PLANNING COMMISSION MEETING STAFF REPORT

NAME OF PROJECT: Daybell Garage Mixed Use Project – Restaurant and Residential Unit

AGENDA ITEM: Conditional Use Permit

Subject: Daybell Garage Conditional Use Permit Review

1 SITE PLAN
Scale: 1/8" = 1'-0"

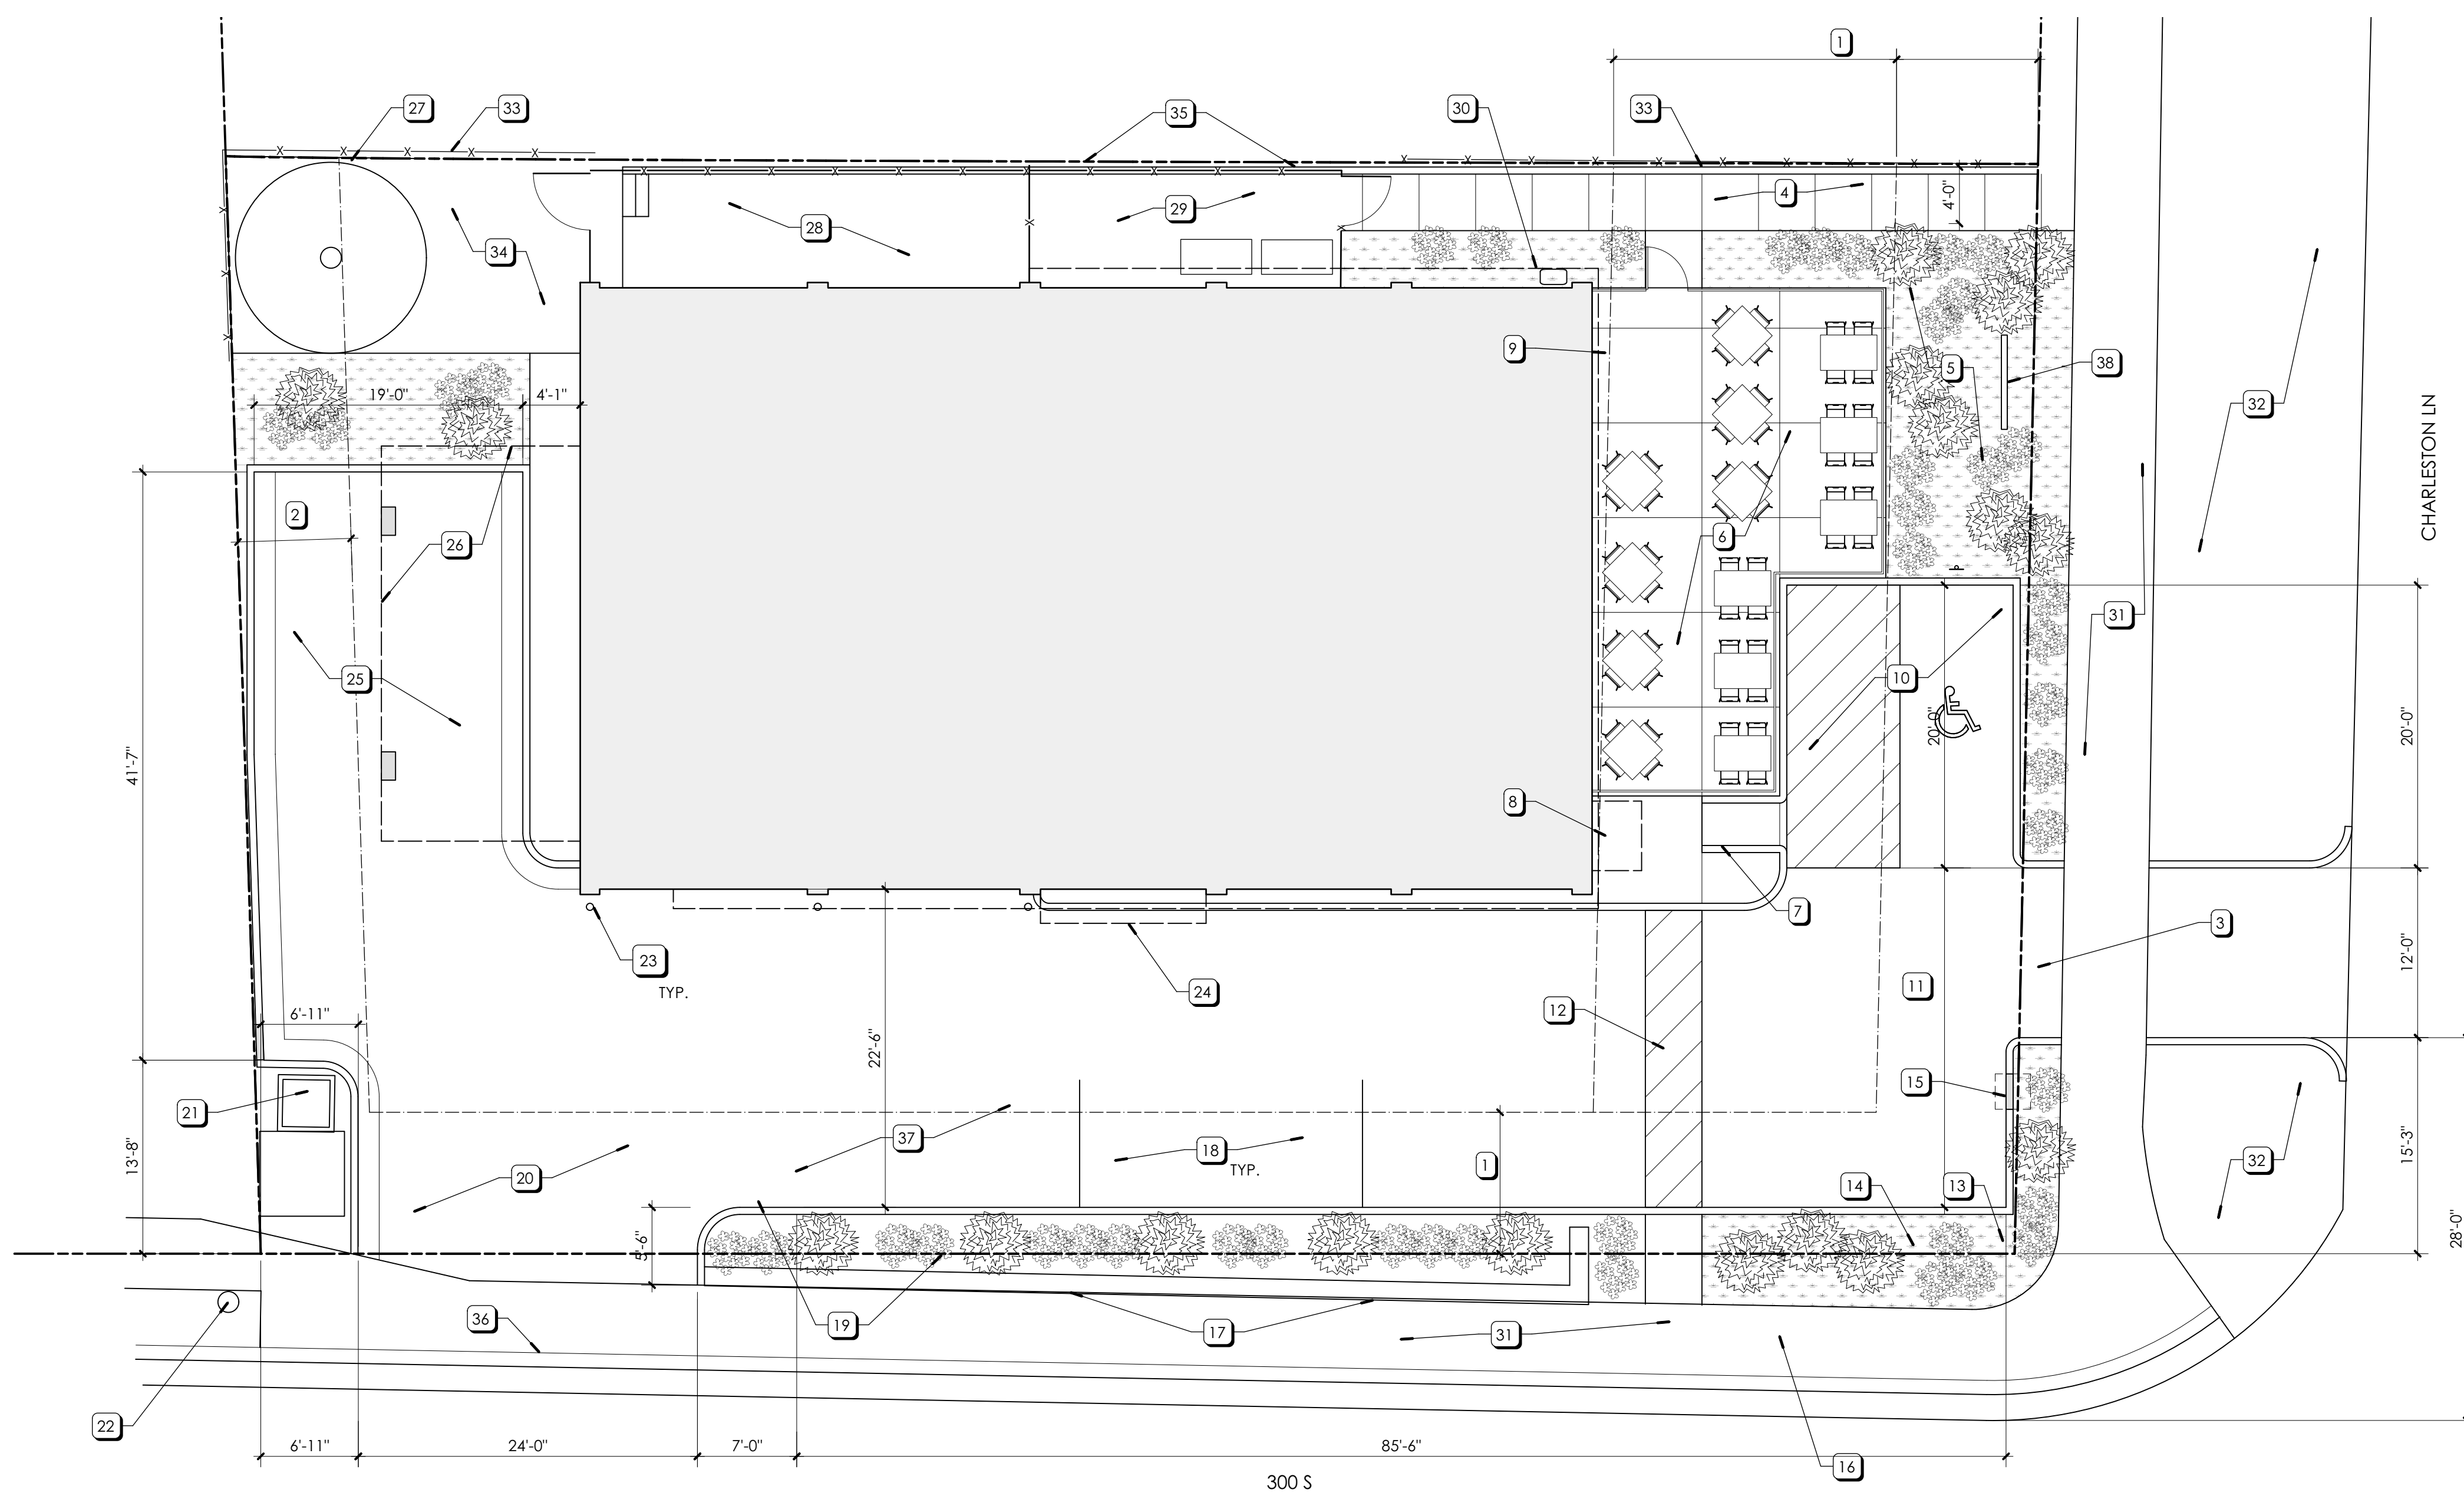
Setbacks – All structure setbacks will remain the same except for the setback to the west property line. The applicant is proposing a balcony for the residential unit. The C-2 Zone requires a 10' residential setback when part of a mixed-use development. It appears that the setback to the balcony does not meet this and will need to be adjusted so that it complies.

1. Must have a recommendation from the water board before being presented to the City Council.
2. Must obtain a will-serve letter from Midway Irrigation Company before being presented to the City Council.
3. Must have approval from UDOT before being considered by the Planning Commission.
4. Before a building permit is issued, the applicant will need to address the items outlined in the Horrocks Engineering review letter dated 9/14/21.
5. The setback from the west property to the residential balcony must be a minimum of 10’.

1 SITE UTILITY & DRAINAGE PLAN
Scale: 1/8" = 1'-0"

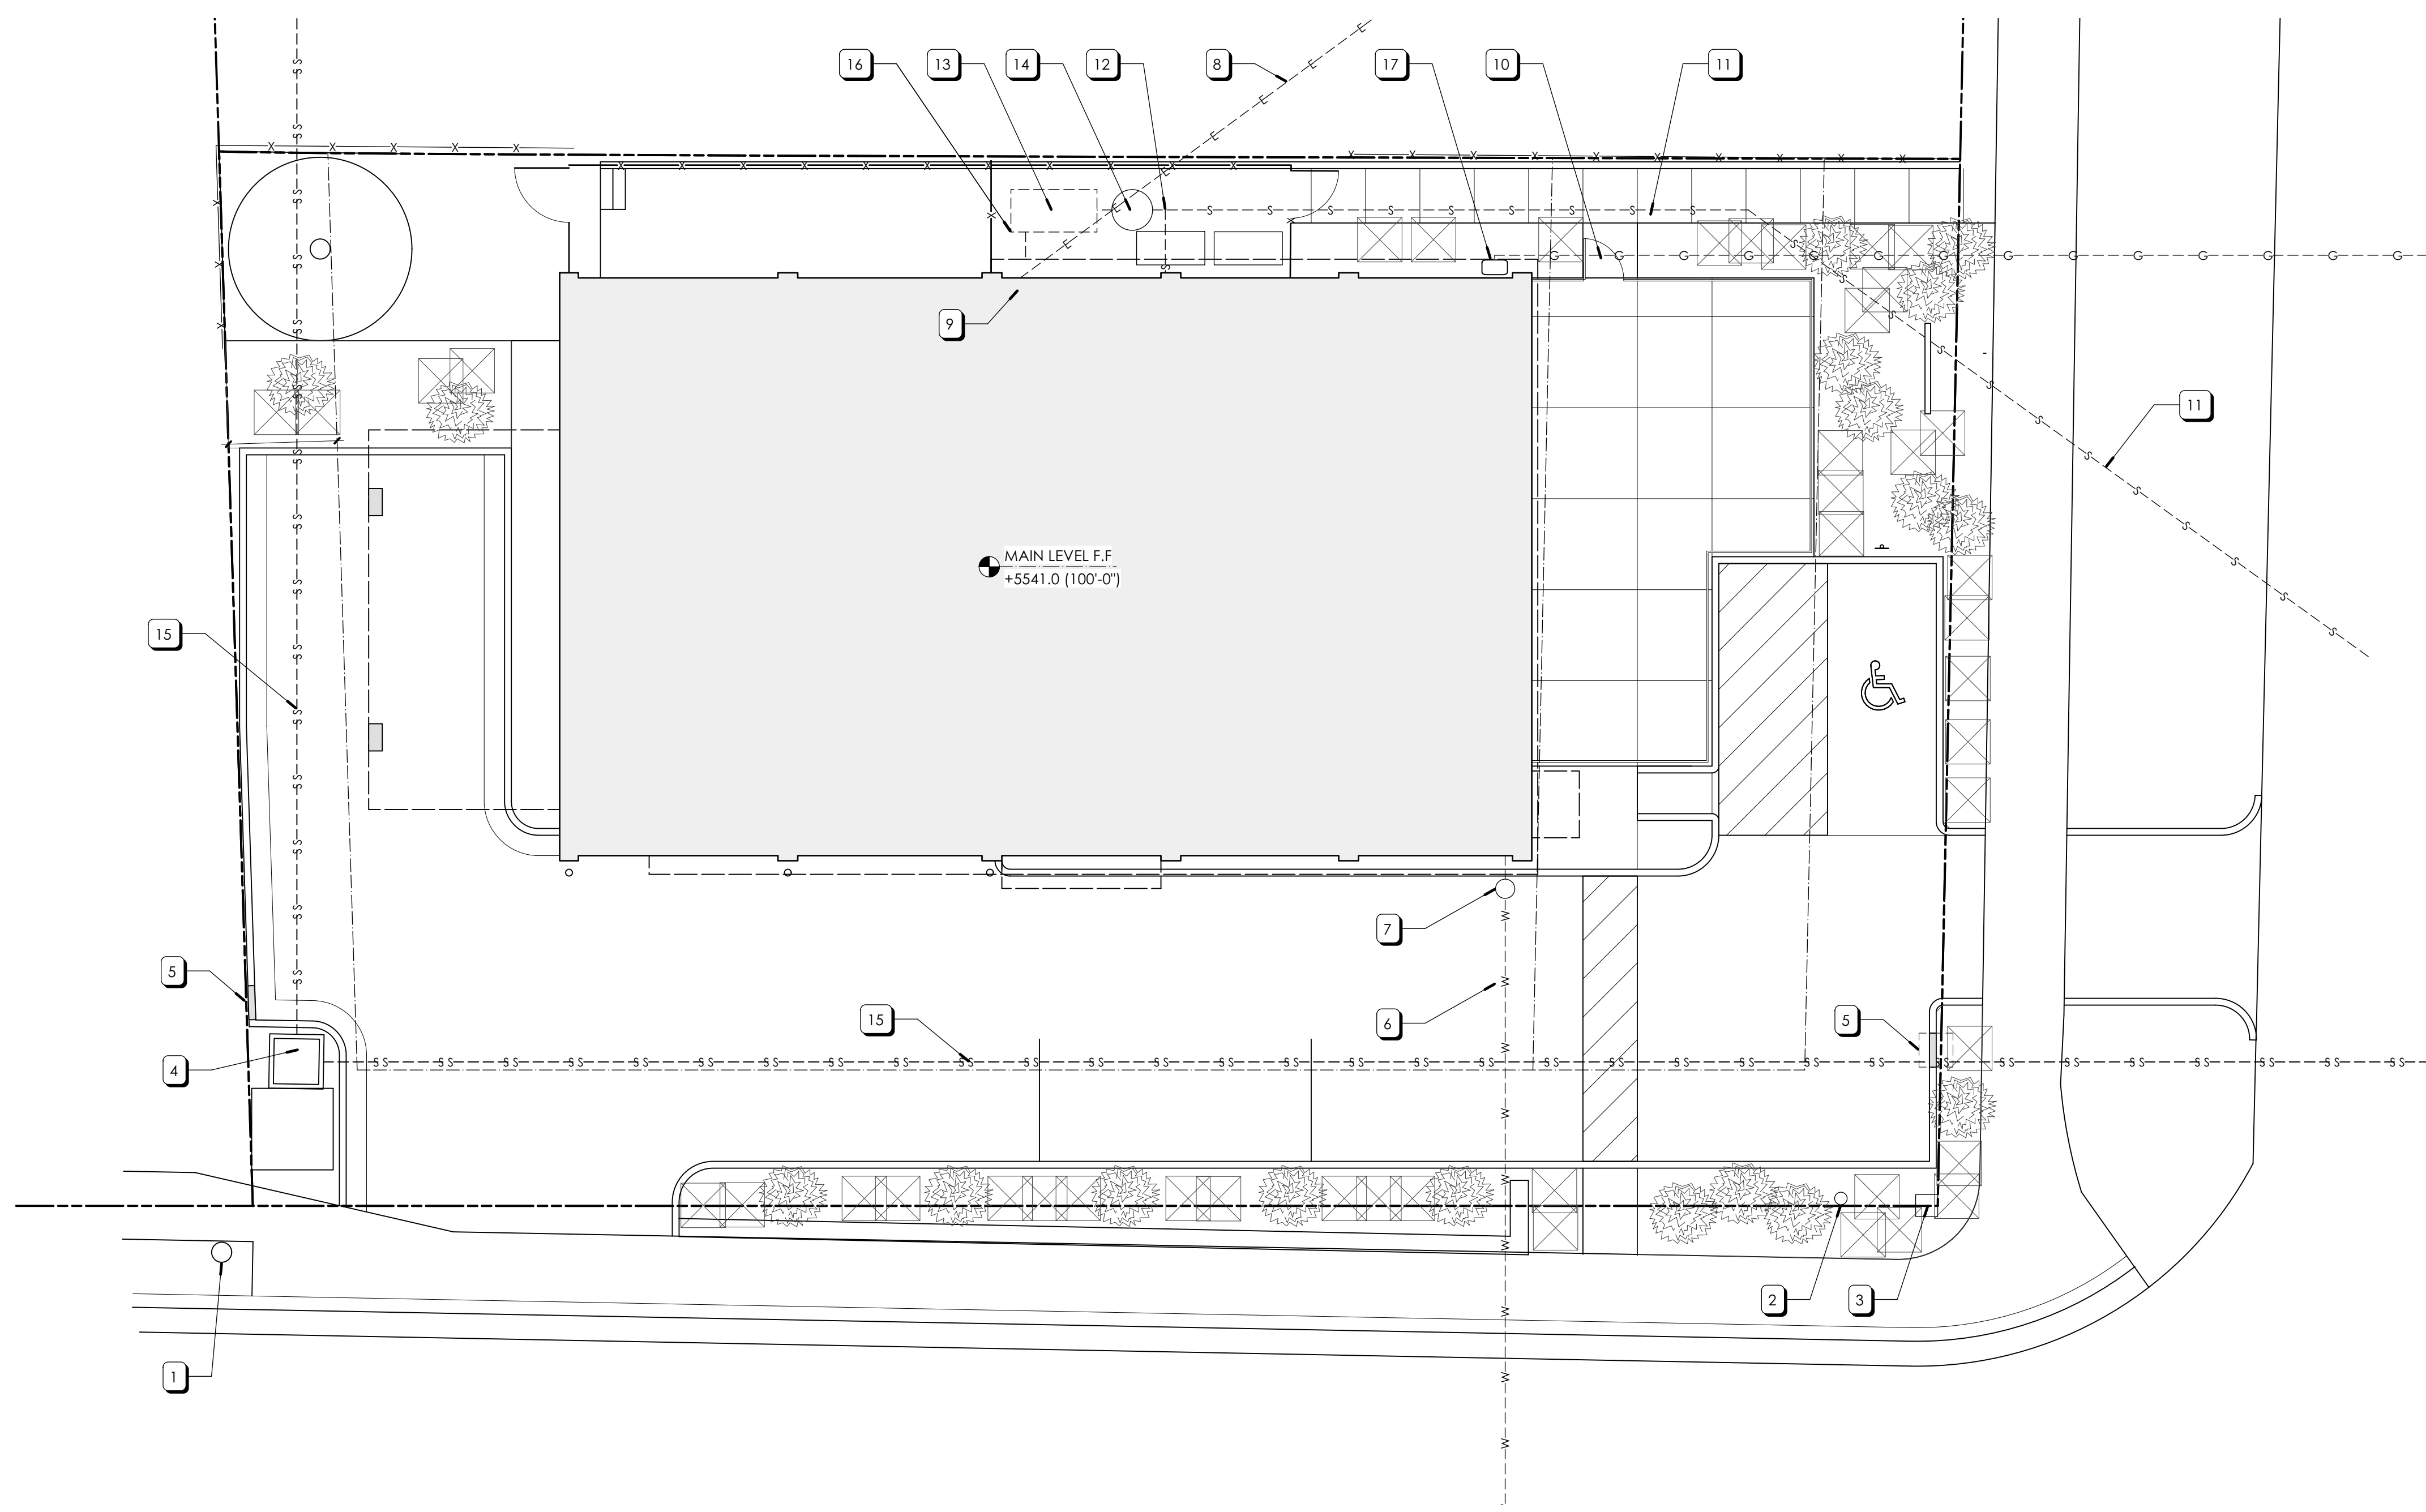
- Applicant should verify that the existing lateral has adequate flow for both the restaurant and residential unit.

- The site will need provide a storm drain analysis for 25 year – 24 hour storm event and hold that water onsite. Then it can discharge into the existing irrigation line that runs through the property and south on Center Street.
